Sydney Cricket Ground Stage 2—MA Noble/Bradman Redevelopment Proposed by Sydney Cricket and Sports Ground Trust

MP08_0103 Section 75(w) Amendment—Heritage Impact Assessment

D-12A - COMPARISON

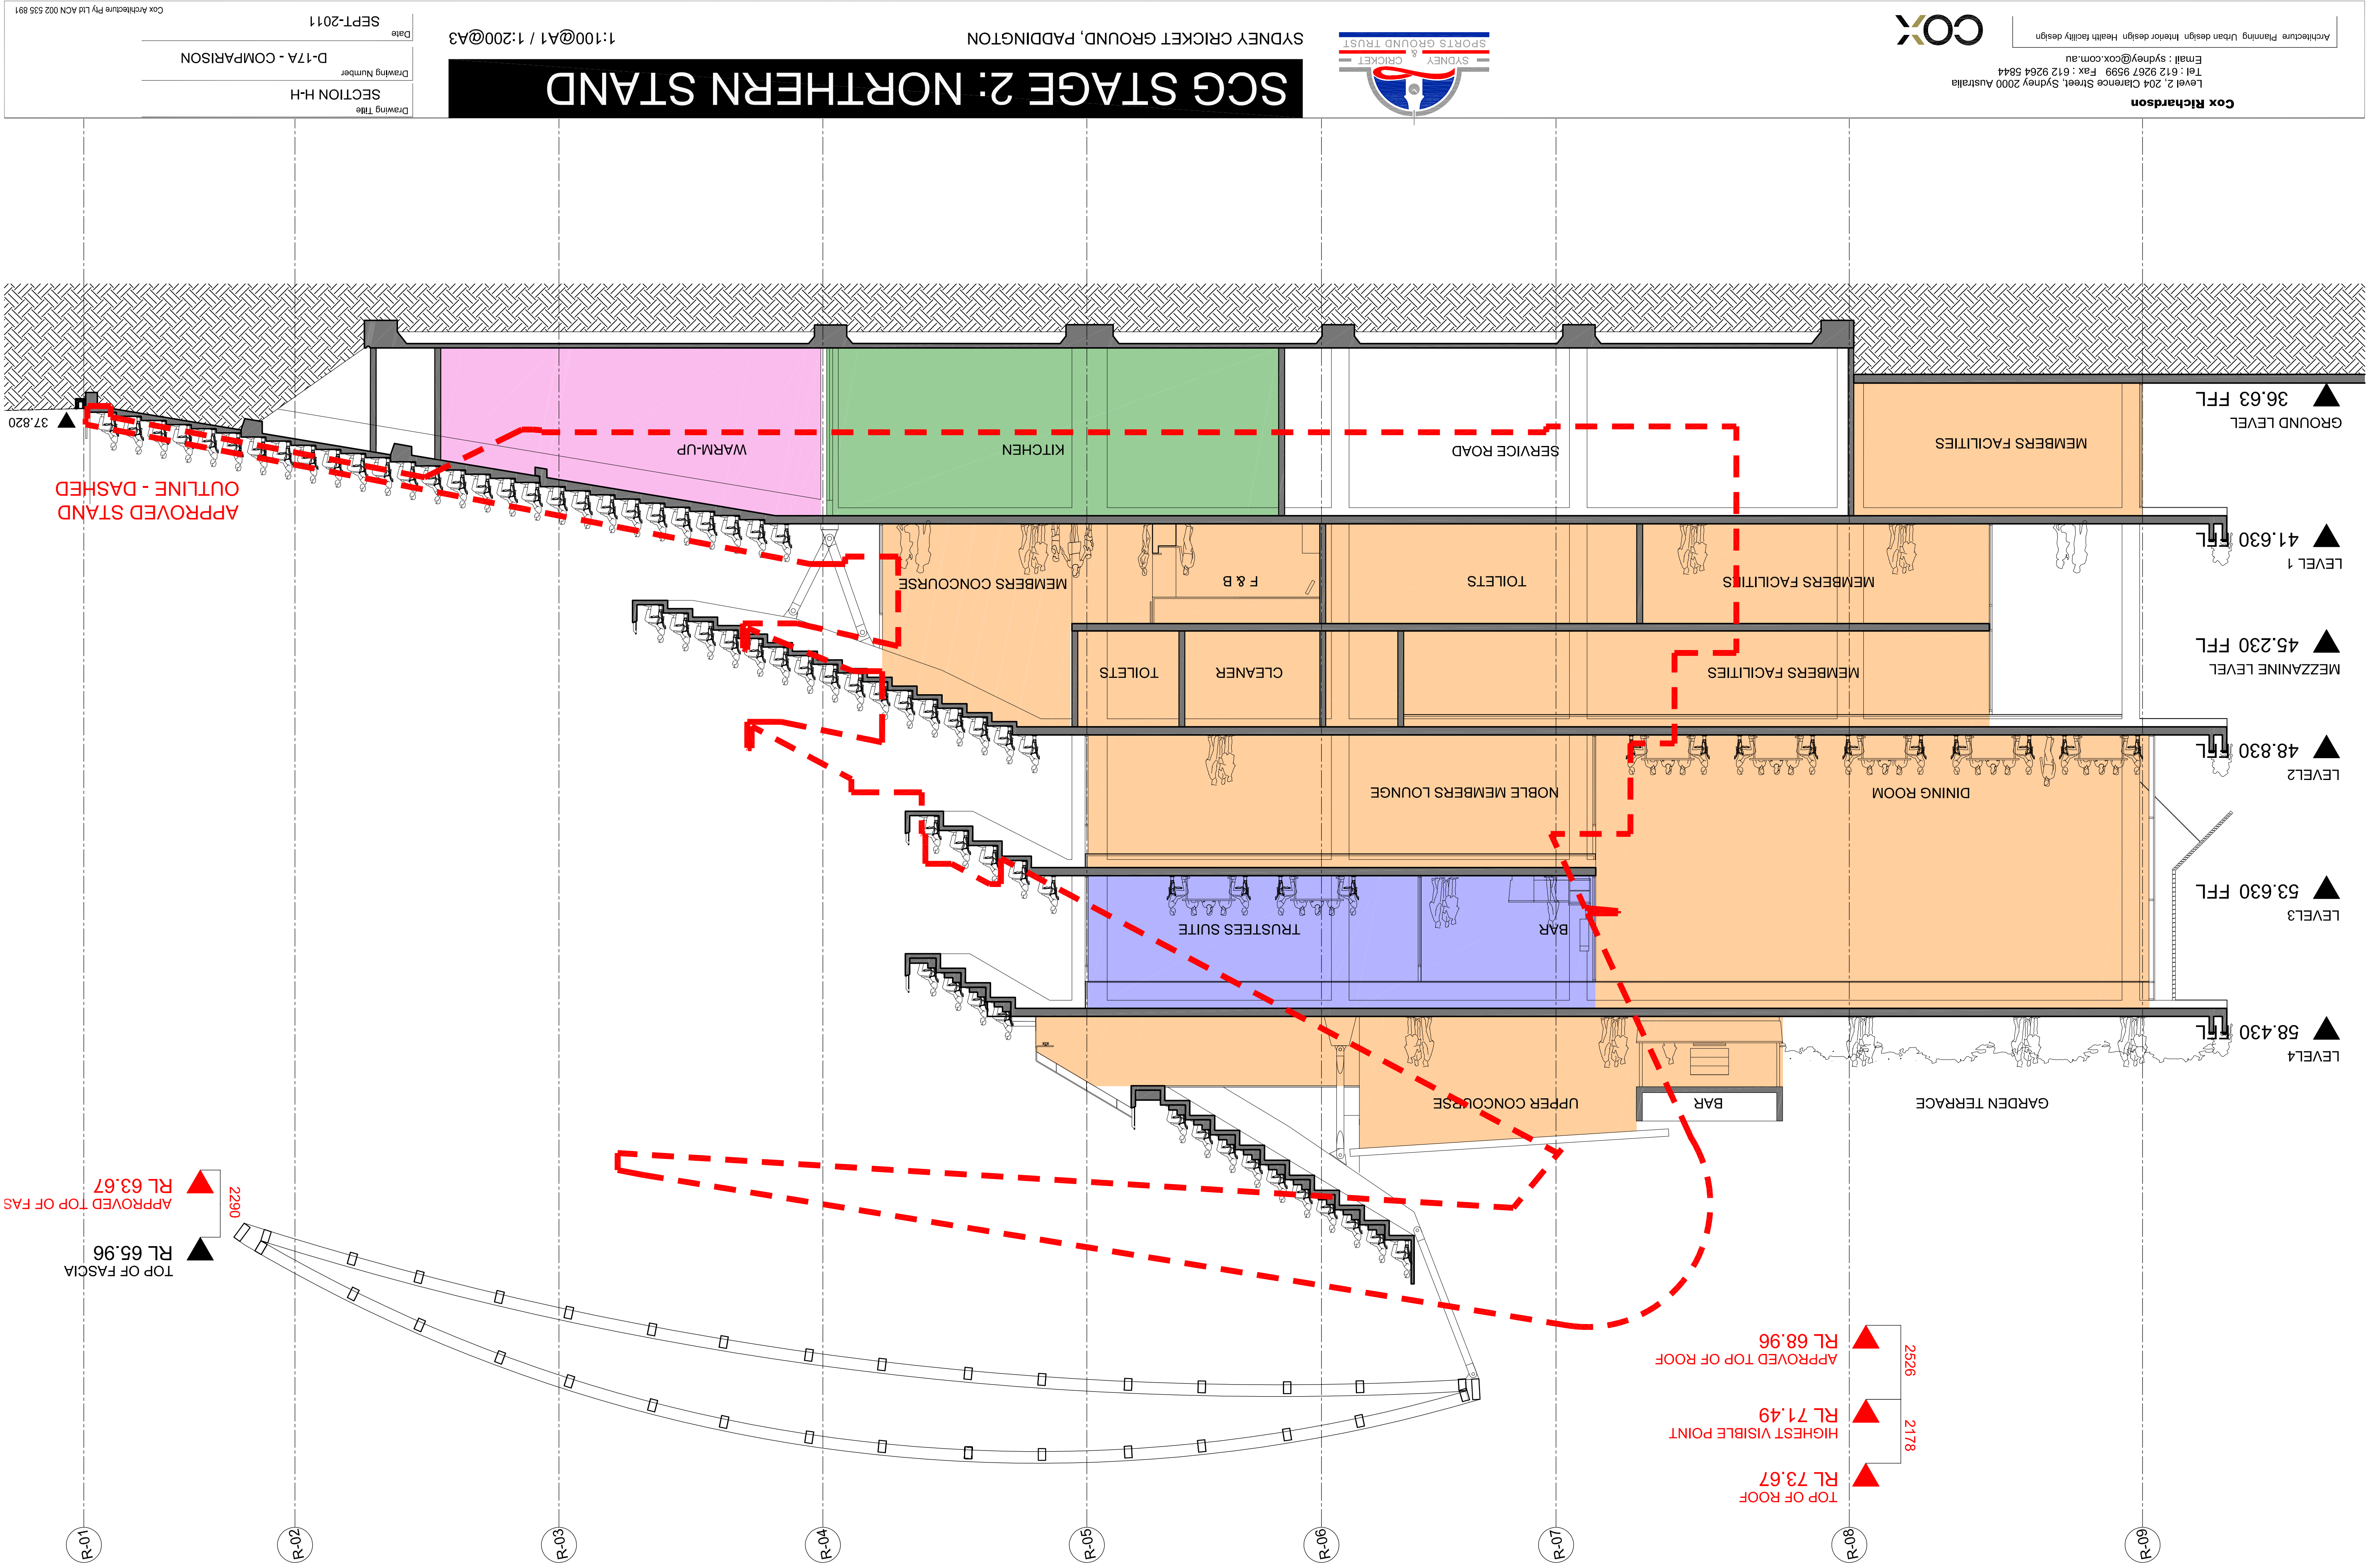
New grandstand is higher than the existing Noble and Bradman Stands and significantly higher than Members Stand.	The leading edge of the roof will be 2.77m higher than that approved. The rear edge falls from the centre towards each end. The highest point of the roof will be 5.3m higher than the rear of the previously approved roof of the new stand.	The additional height will add significantly to the contrast between the members and Ladies stands.

Previously Identified Impact of Approved Application	Impacts Under Current Proposal	Assessment of the Impact of the Current Proposal
Western Tower (clock tower) retained as a transparent/neutral element to assist in transition between the two structures.	The Western Tower façade is retained as a transparent/neutral element to assist in transition between the two structures. However, the increased bulk, character, form and scale of the new rear of stand structure diminishes the ability for the tower to be read as a transition element. Use of terracotta to define eastern upper area of the tower may assist to differentiate the Tower from the bulk and massing of the new building.	Additional heritage impact as the prominence of the Western Tower façade is reduced by the height, bulk, character and scale of the new stand to the north.
New roof set back from eastern end of Members' Stand by 15m (existing setback is 5m).	New roof set back 10m from the eastern end of the Members' Stand.	New roof form is 5m closer to Members Stand and 2.7m higher than approved roof form.

Drawing Title
GROUND FLOOR PLAN
Drawing Number
D-02C - COMPARISON
Date
SEPT-2011

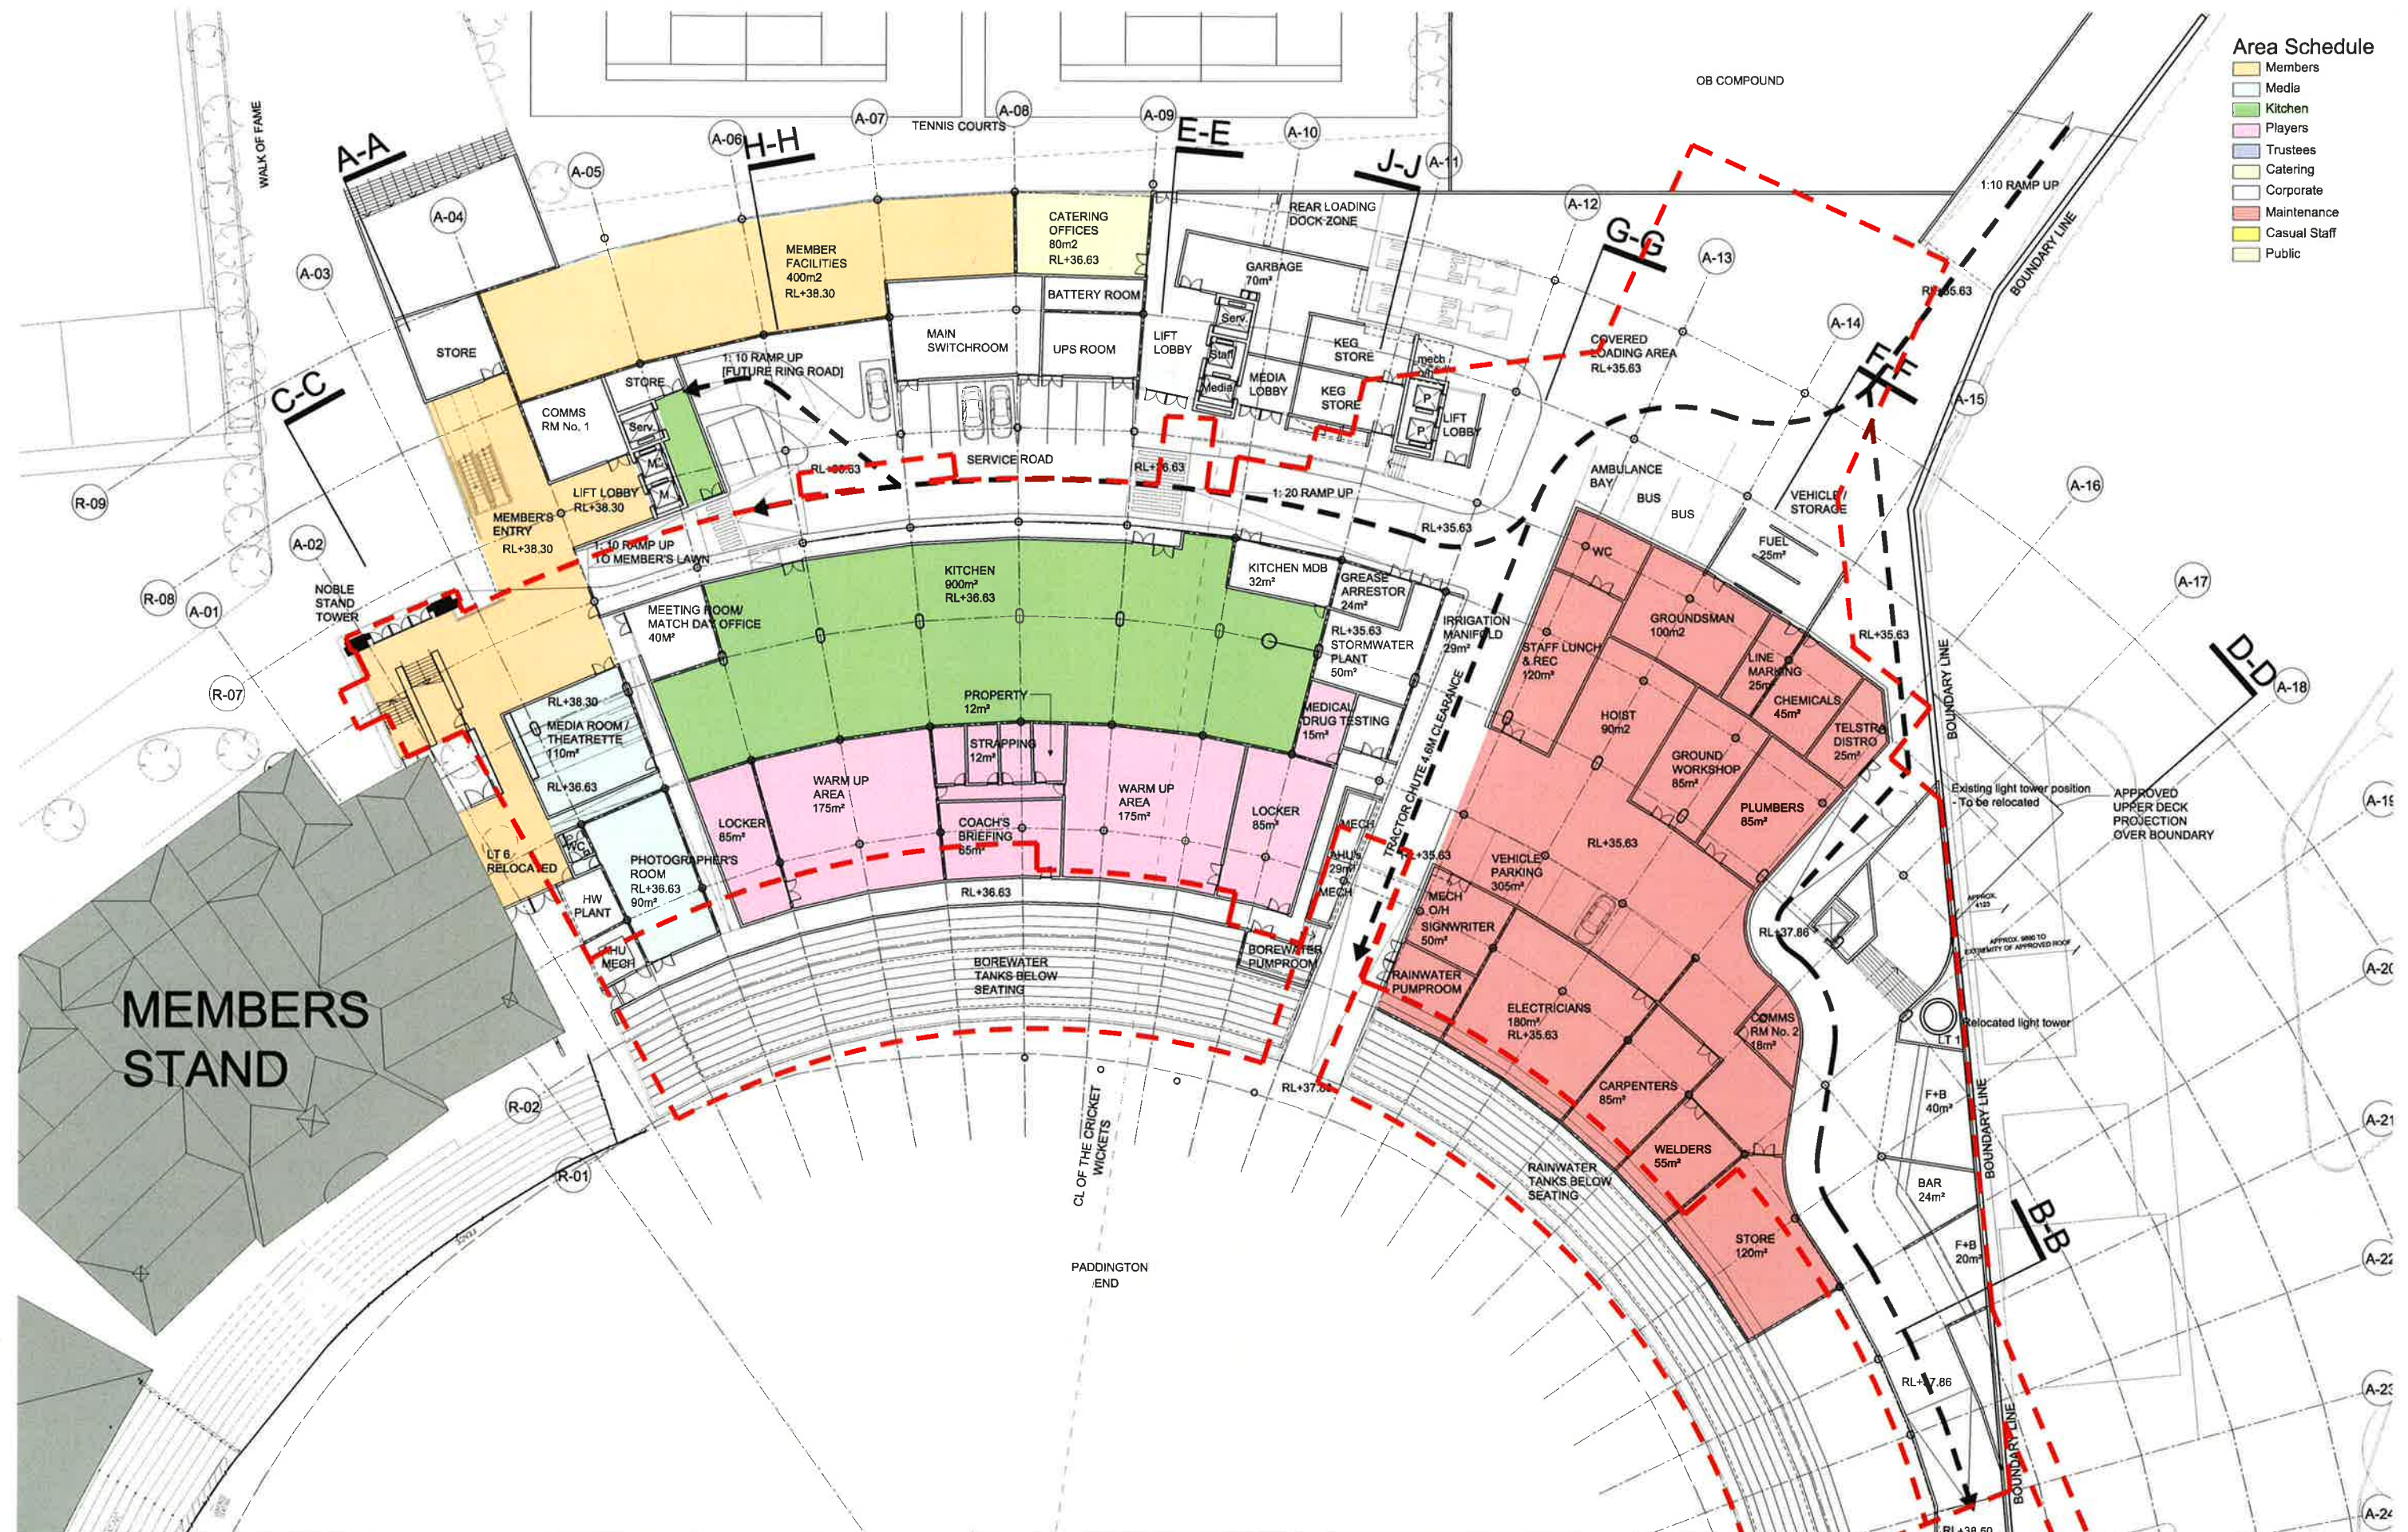
Building line behind the north face of the Western (clock) Tower.	The larger scale of the new stand's facilities results in a building line that is well forward (north) of the north face of the retained Western Tower façade. The service road is enclosed by the extension of the new stand to the north.	The additional height, bulk, character and scale of the rear of the stand structure sitting forward (north) of the line of the retained Western Tower facade is an additional impact on the setting of the Members' and Ladies' stands, and on the western tower of the Noble stand. The new rear of stand structure has been stepped down and back to reduce its impact on views of the Western Tower façade from the Walk of Honour.
The tower remains prominent in the views from Driver Avenue.	In views from Driver Avenue, the tower will be seen against the bulk of the new stand projecting further north.	The increased scale and bulk of the rear of the new stand to the north impacts the prominence of the views of the Western Tower façade from Driver Ave as it is now seen on approach against the substantial additional scale and bulk of the northern and western elevations of the new grandstand.

Previously Identified Impact of Approved Application	Impacts Under Current Proposal	Assessment of the Impact of the Current Proposal
	The service road will be relocated inside the new stand bringing the rear of the stand closer to the Sydney Football Stadium.	Loss of two tennis courts of Moderate significance and the reorientation of the two remaining courts will change the landscaped approach, subject to future detailing
Views		
Retained Western Tower of the Noble Stand is prominent in views from the north west (Moderate) Walk of Honour and Members' Garden.	Bulk of new stand enters views from the Walk of Honour and Members' Garden. Prominence of Western Tower facade is diminished.	Prominence and views will be impacted but an analysis of options has led to a reduction of potential impacts on the tower by stepping back and lowering the additional rear of stand building bulk around the flights of access stairs and escalators.
